ARCHITECT'S SUPPLEMENTAL INSTRUCTIONS

Date Issued:	March 5, 2020
Project:	Intermountain Healthcare Tooele Valley Dialysis Clinic Expansion 2356 North 400 East, Suite #102 Tooele, Utah 84074
Architect's Supplemental Instructions:	ASI #1
To:	Saunders Construction 1113 South 500 West Bountiful, Utah 84010

RE: ASI-001 – Department of Health Requests

Electrical ASI #01

PP101

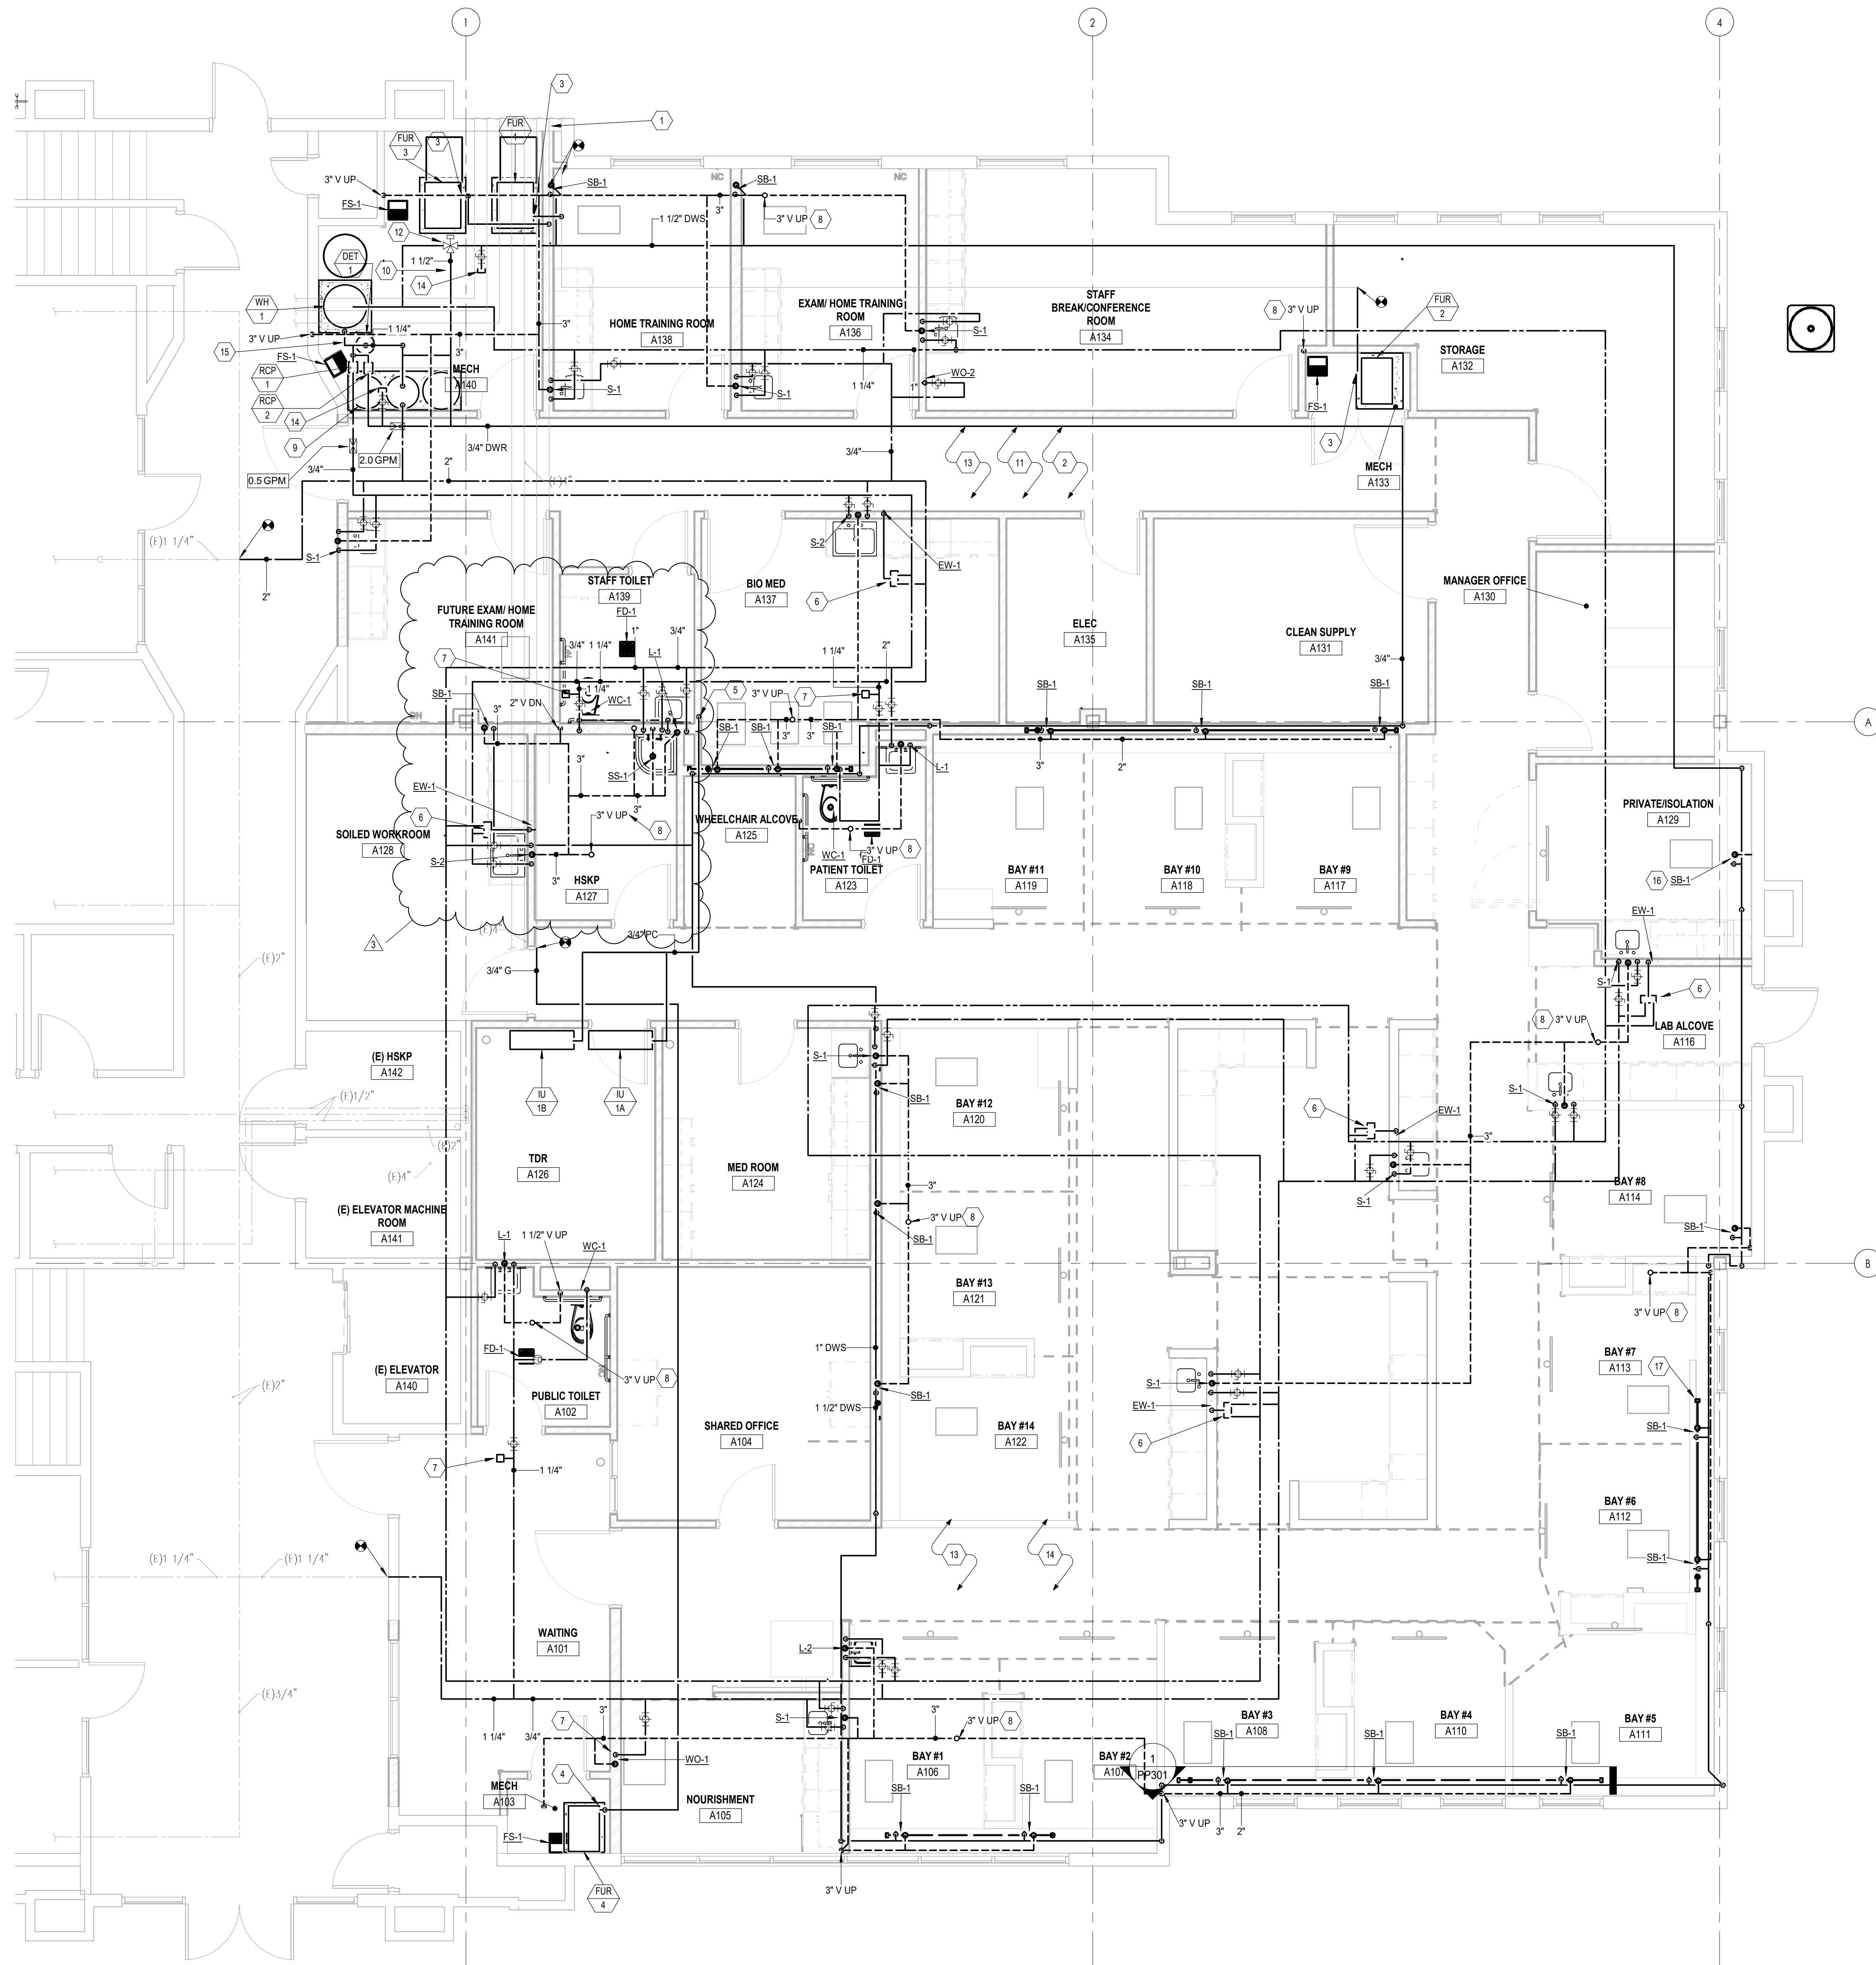
1. Plumbing updated to match relocated fixtures.

EP101

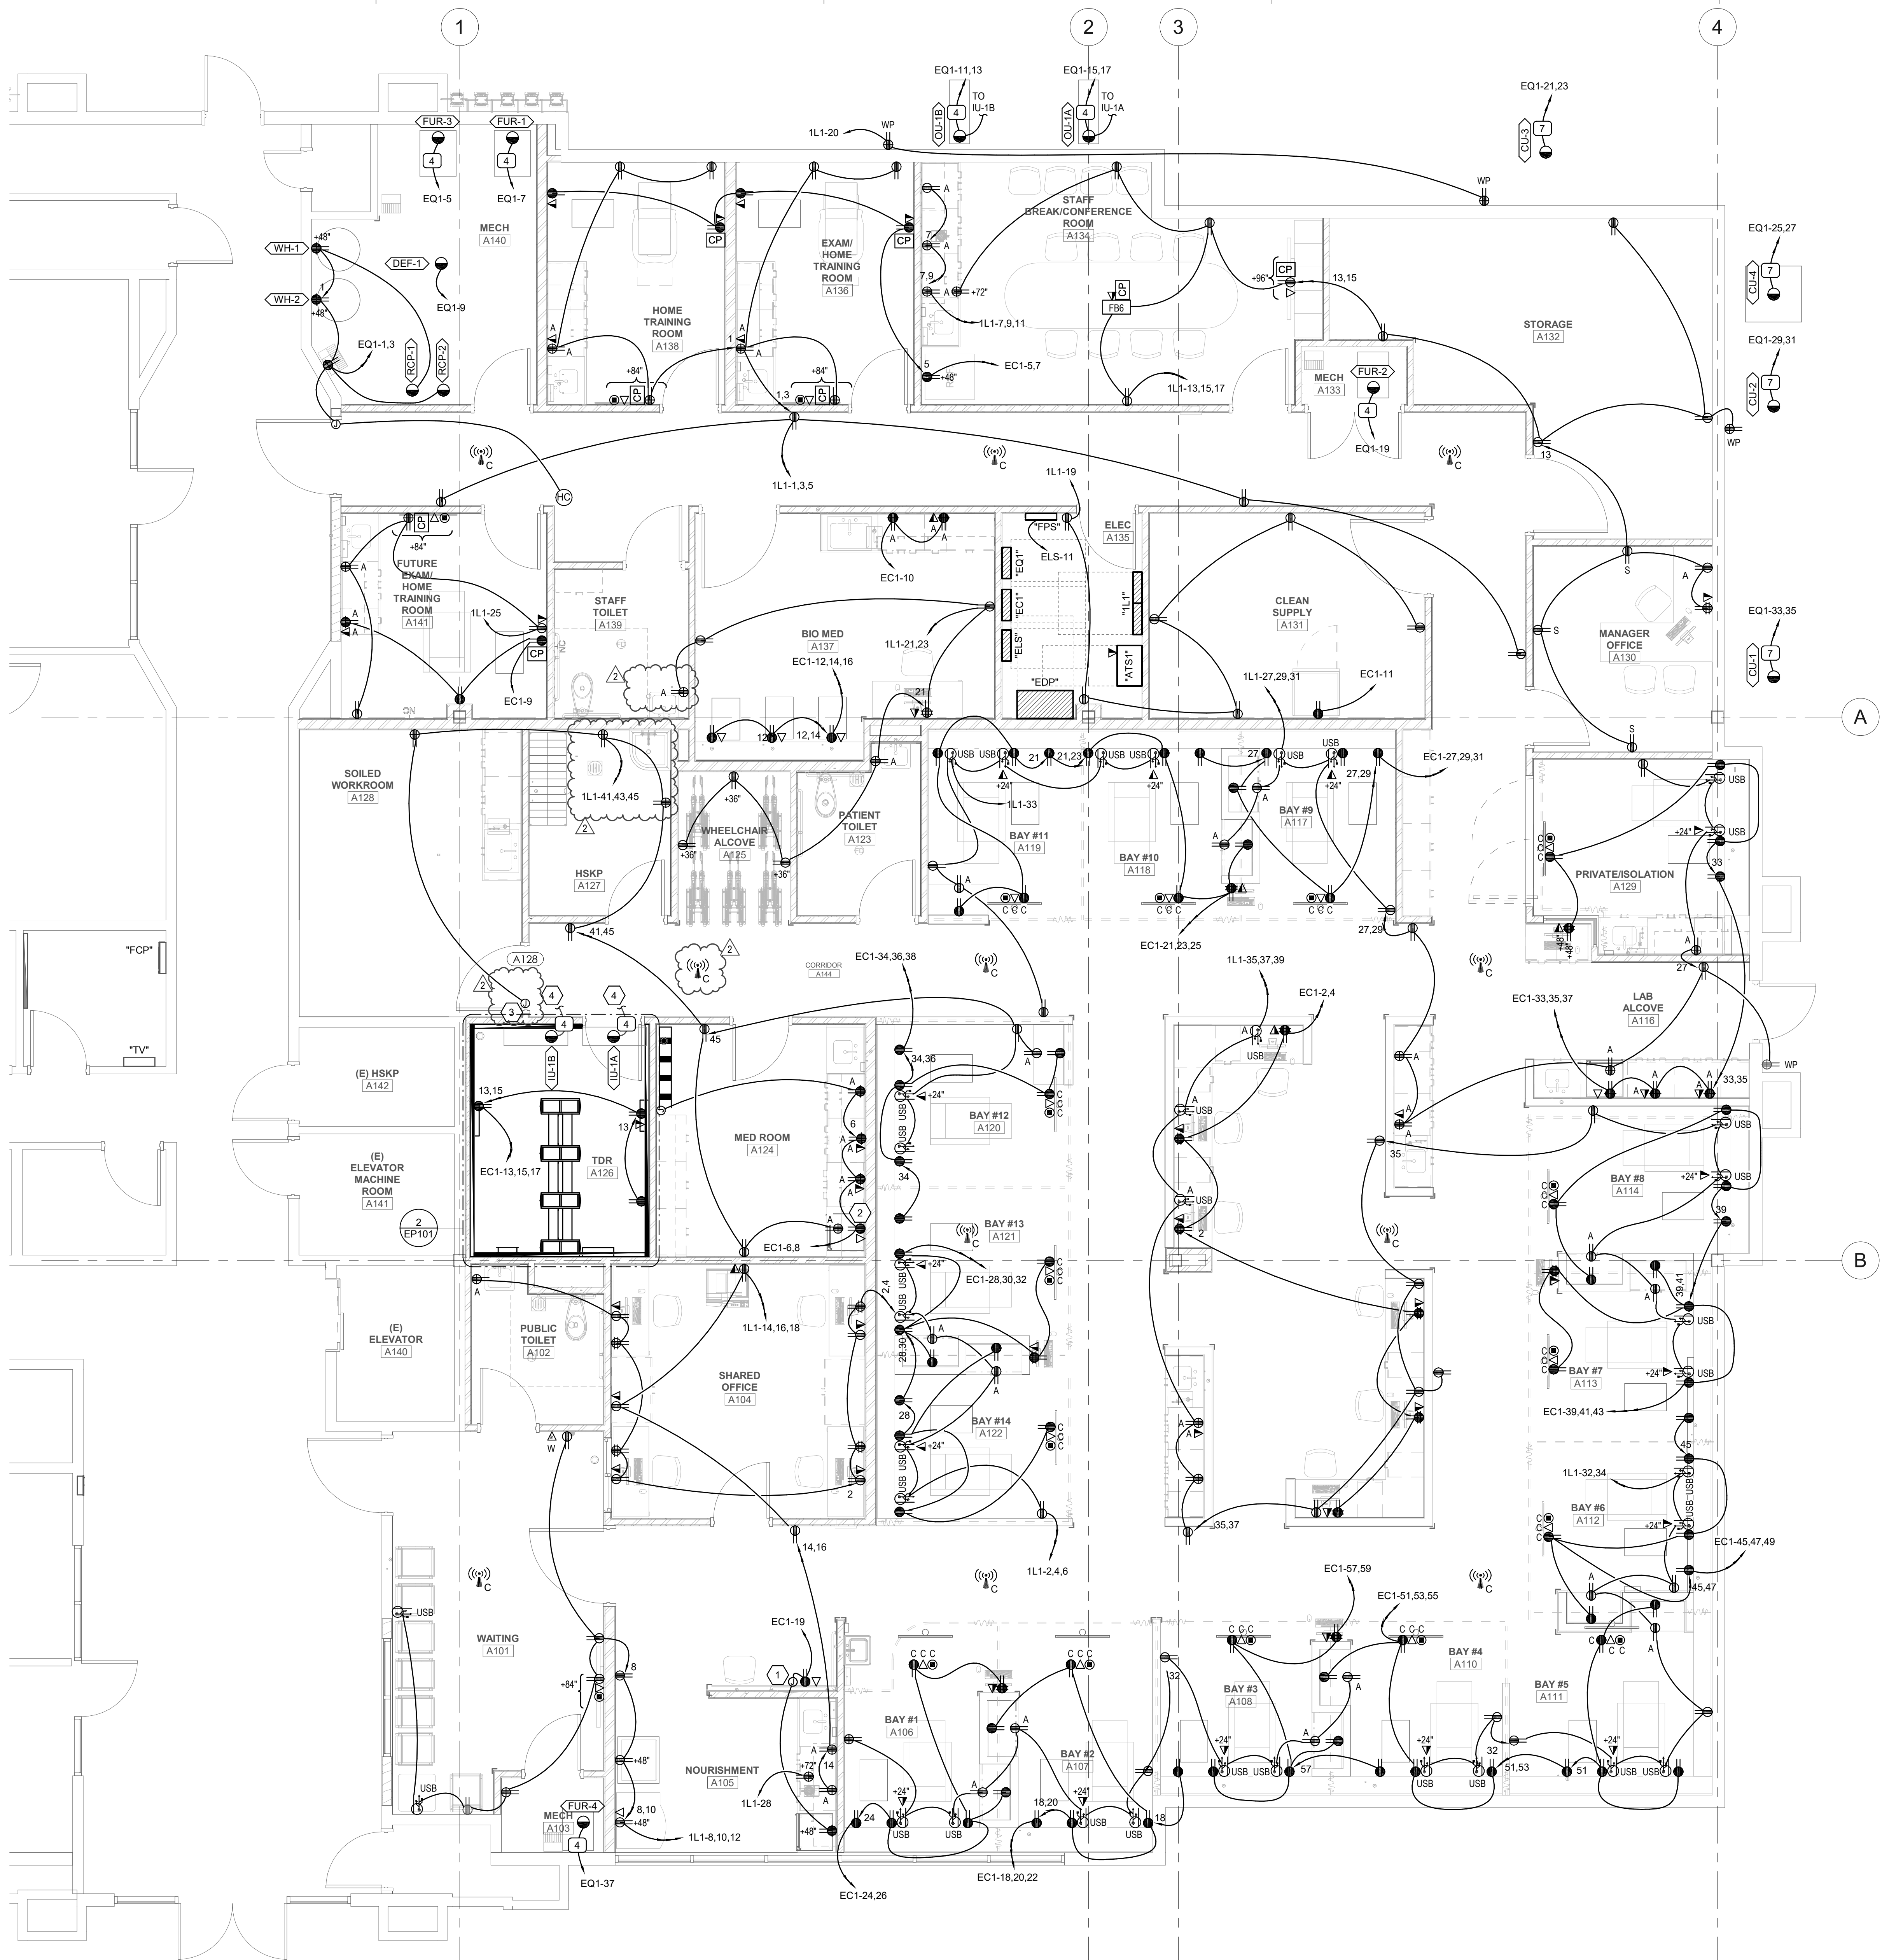
1. Located GFI power receptacles to housekeeping A127 and above counter GFI to A139.
2. Relocated the power for the safe zone closer to new door A128 location.
3. Relocated WAP to corridor A144.

EL101

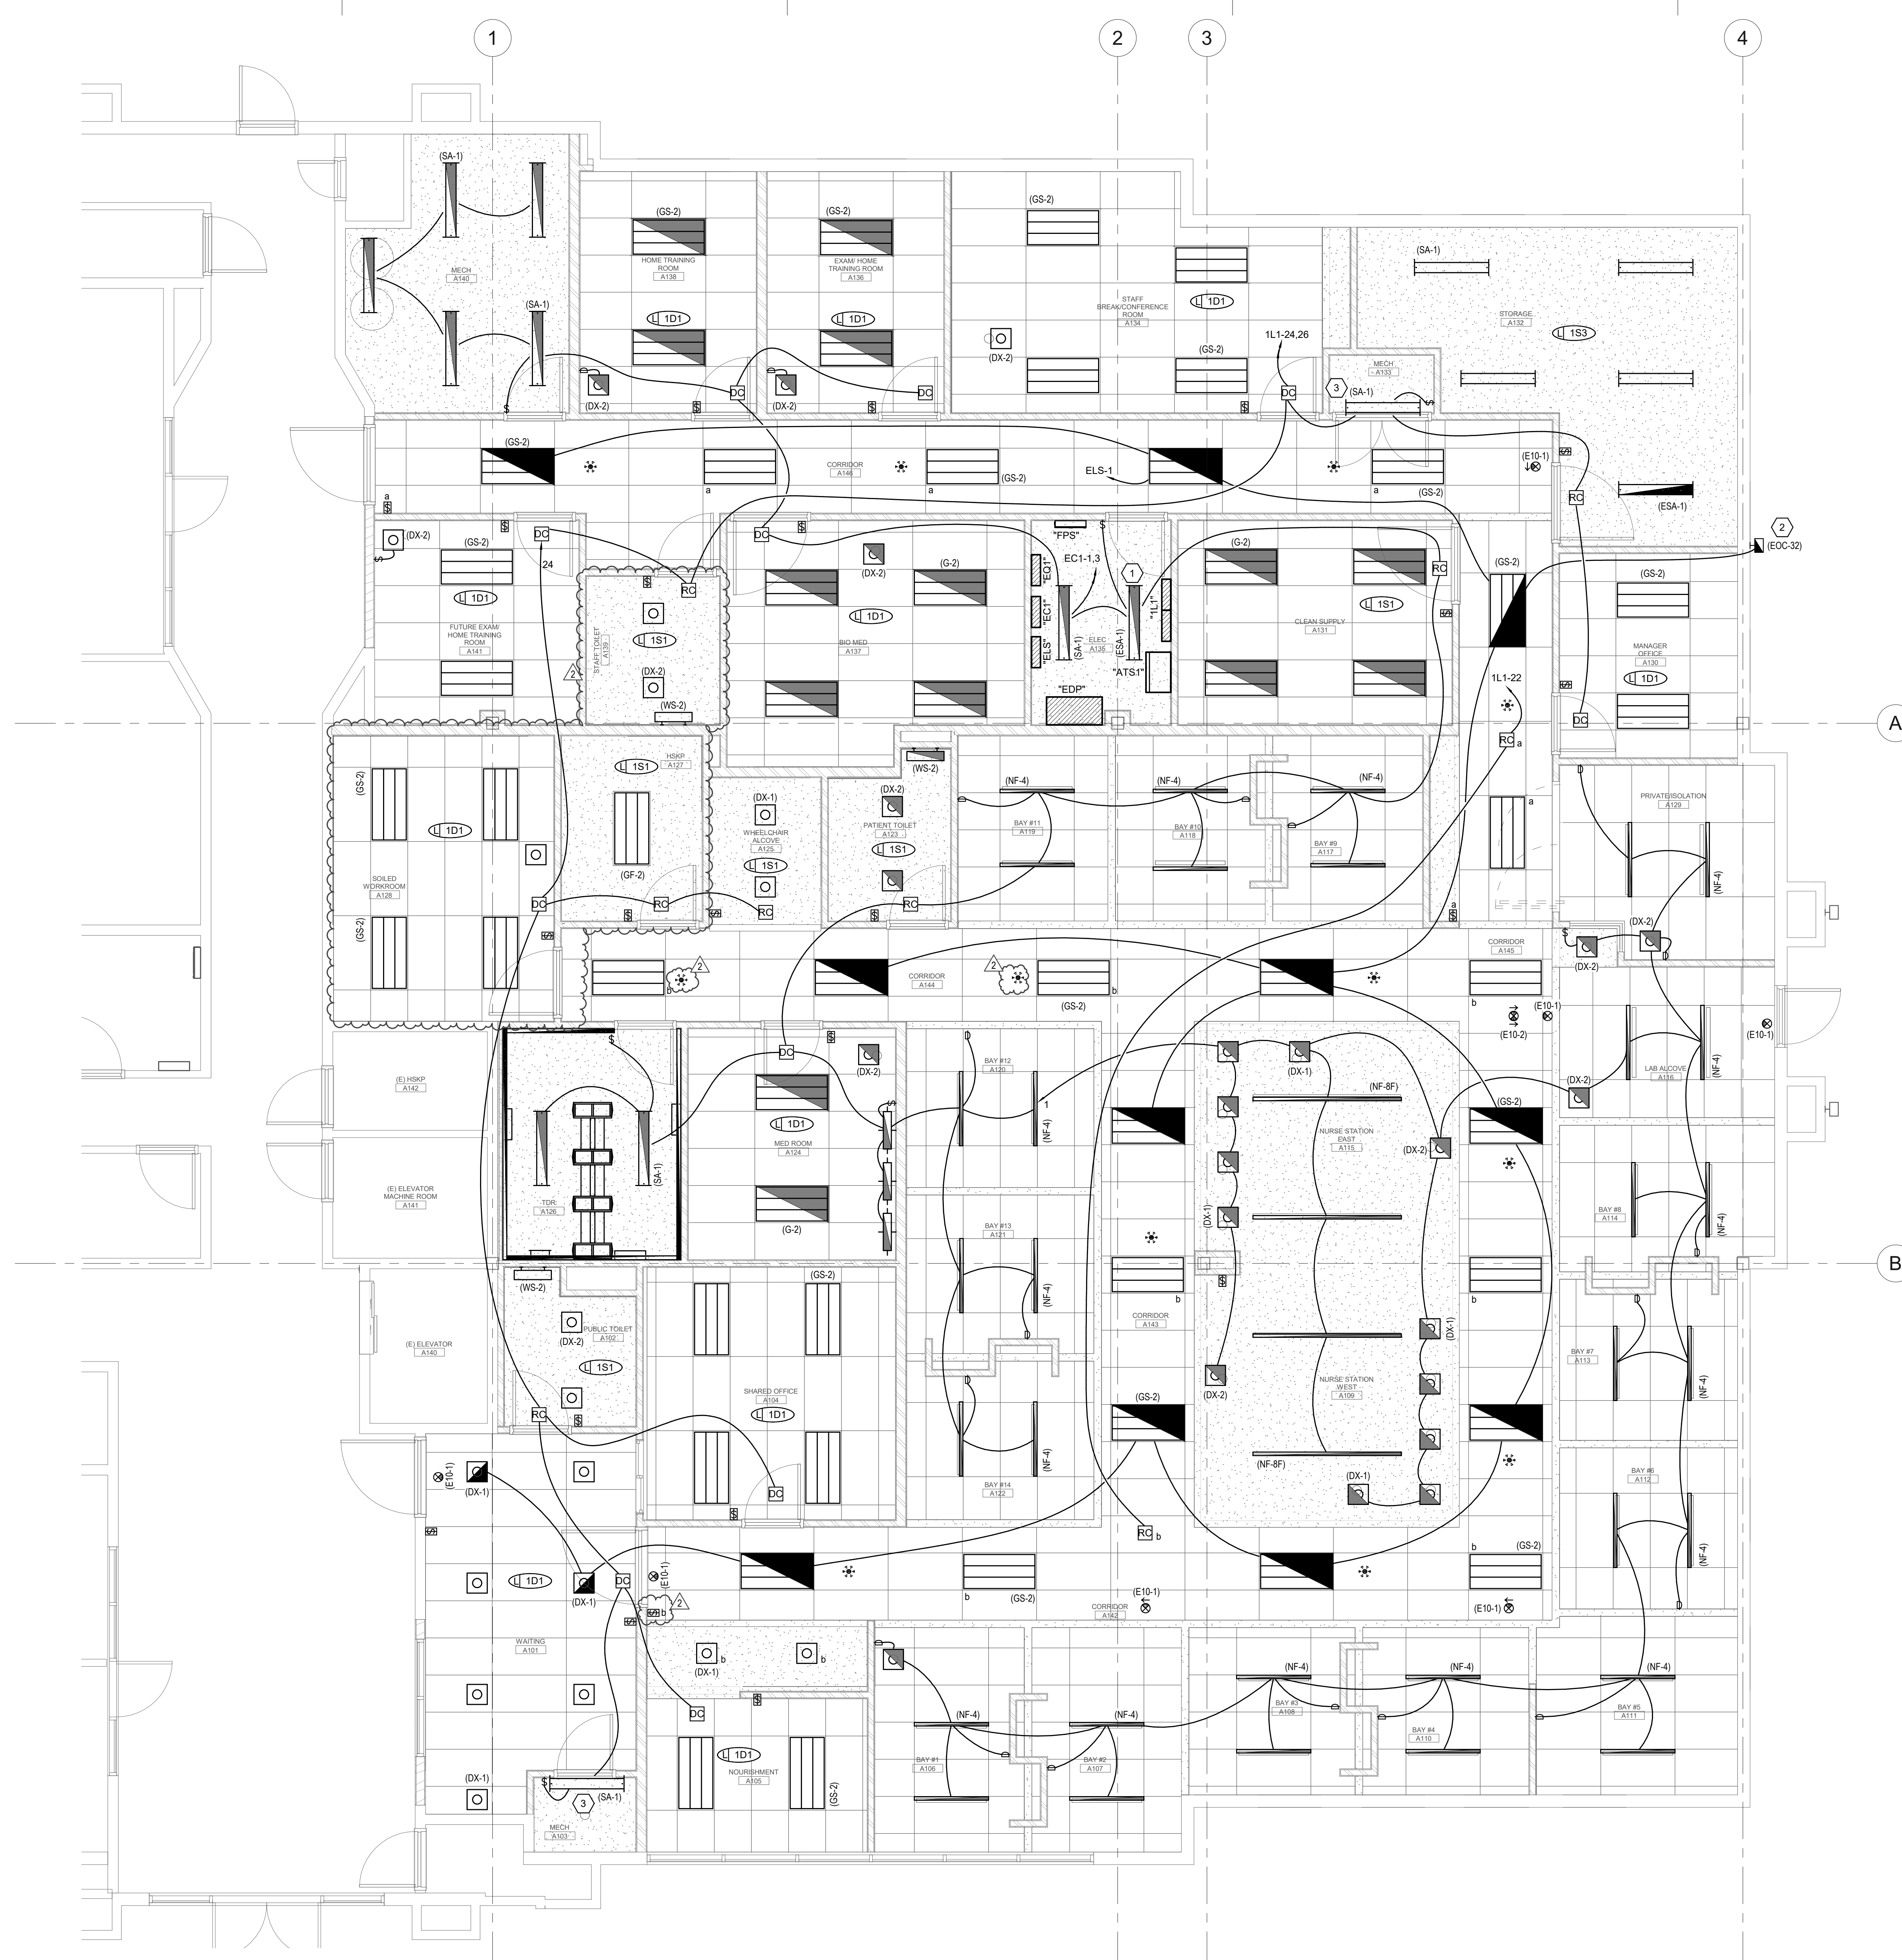
1. Relocated lighting sensors in corridor A144.
2. Relocated corridor light switch to A142.
3. Added new light fixtures to A128.
4. Revised Housekeeping A127 lighting.
5. Revised Staff Bathroom A139 lighting.
